Project **SECURICOR DISTRIBUTION CENTRE, HATFIELD**

PROPOSED AMENDMENTS TO MOUNDING (Sheet 2 of 2)

Drawing No. 2143.06	Revision A
---------------------	------------

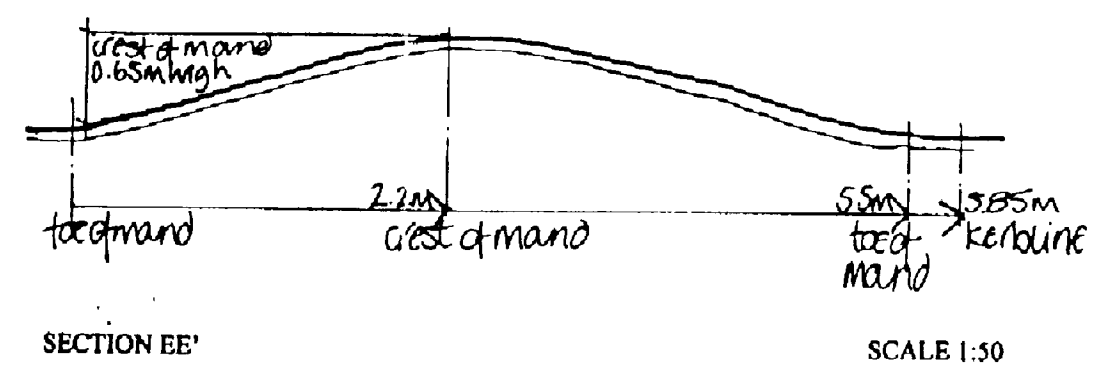
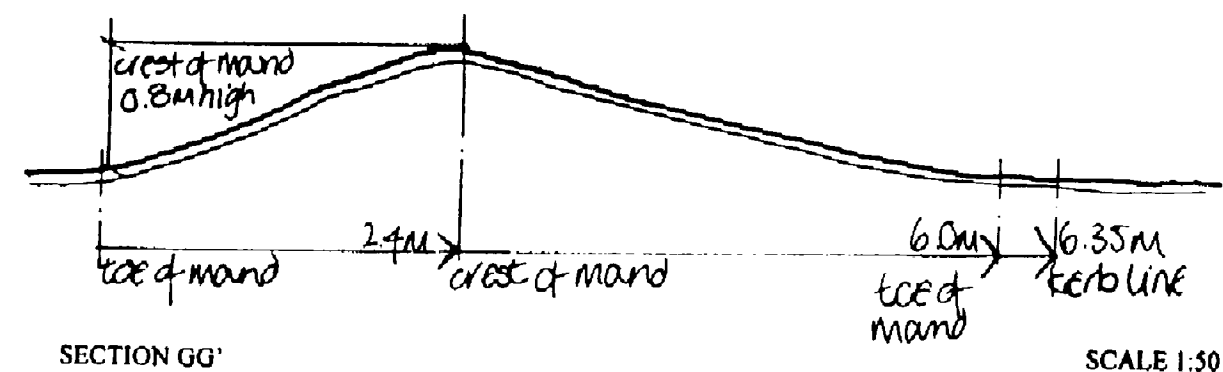
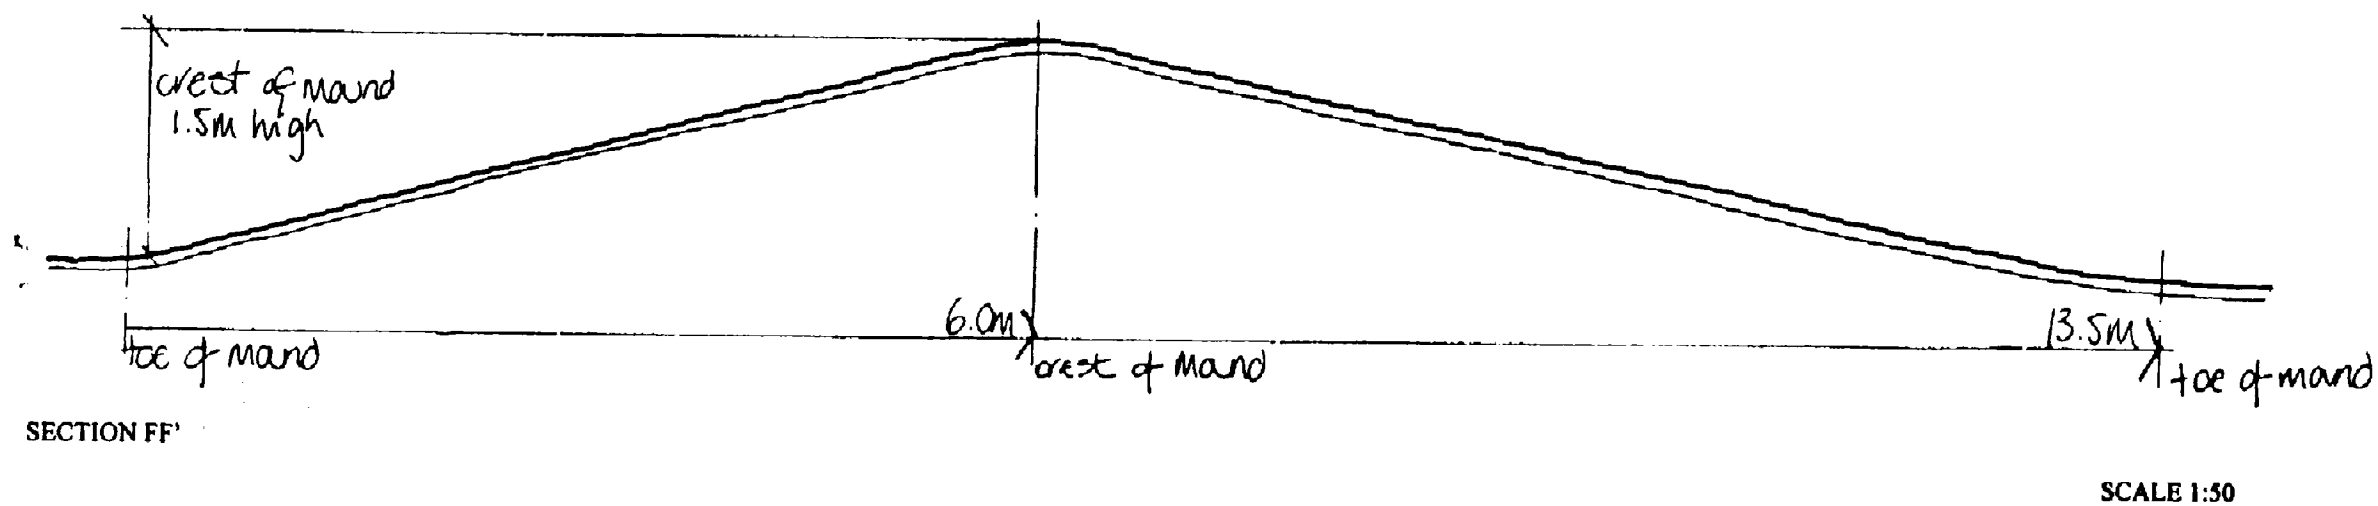
NOTE:
REV.A- MOUNDING AMENDED AS PER TURNER DESIGN
& BUILD FAX MESSAGE. 9.10.97
